Technical Bulletin CS-10-11

SpectraLink 6300 Cards – Rev B Infrastructure

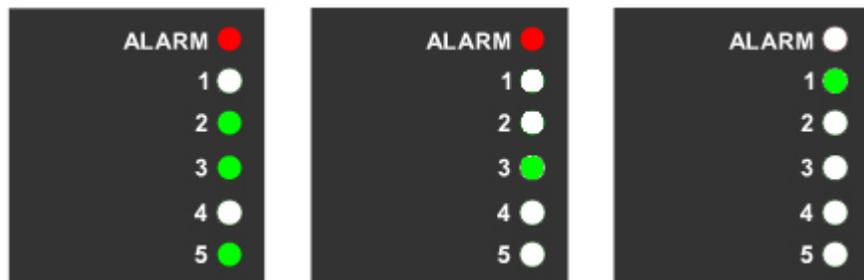
There has been a component software change that affects the SpectraLink 6300 Controller Cards. The changes are due to an identified timing issue within a component on the cards, and will not add any new functions or features. The cards can be identified by a revision label on the front panel. They will be labeled “Rev. B” (see example below).

If you are experiencing the errors described please contact your support representative to discuss options. It may be necessary to replace the “Rev. A” controller to obtain a “Rev. B” controller to resolve the issues.
